# Access Compliance Report

## Public Rights-of-Way

### (Curb Ramps)

Intersection ID: 23357	Main Street: SHARON_RD_WEST	Cross Street: SHARONBROOK_DR	Location: SW
ADA ID: F7330AB72721	Ramp Type: PerpDiag	Initial Pass/Fail: Fail	Overall Compliance: No
		Severity Score: 12.5

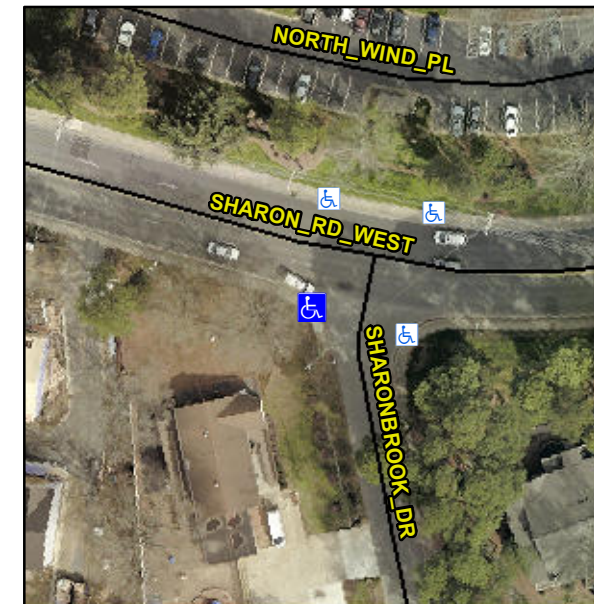
**Not Found, R304.2.2**

Compliance	Description	Data	Compliance	Description	Data
N/A	Ramp Length (in)	60.0	No	Ramp Slope (%)	11.2
Yes	Ramp Width (in)	48.0	Yes	Ramp XSlope (%)	0.6
N/A	Flare Type LT	N/A	N/A	Flare Type RT	N/A
N/A	Flare Slope LT (%)	N/A	N/A	Flare Slope RT (%)	N/A
N/A	Flare Traversable LT?	N/A	N/A	Flare Traversable RT?	N/A
N/A	Landing Length (in)	N/A	N/A	DWS Provided?	N/A
N/A	Landing Width (in)	N/A	N/A	DWS Contrast?	N/A
N/A	Landing Slope (%)	N/A	N/A	DWS Length (in)	N/A
N/A	Landing X Slope (%)	N/A	N/A	DWS Full Width?	N/A
N/A	Landing Curb? (Y/N)	N/A	N/A	DWS Offset (in)	N/A
N/A	Shared Landing?	N/A			
N/A	Gutter Ponding?	N/A	N/A	Gutter Slope (%)	N/A
N/A	Gutter Lip Ht (in)	N/A	N/A	Gutter X Slope (%)	N/A
N/A	Painted X Walk1?	No	N/A	Painted X Walk2?	No
	X Walk 1 Direction	To SE		X Walk 2 Direction	To N
N/A	X Walk 1 Width (in)	N/A	N/A	X Walk 2 Width (in)	N/A
	X Walk 1 Slope (%)	3.5		X Walk 2 Slope (%)	3.7
	X Walk 1 X Slope (%)	3.2		X Walk 2 X Slope (%)	2.6

**Remove & Replace Curb Ramp With Two New Directional Ramps or Equivalent.**
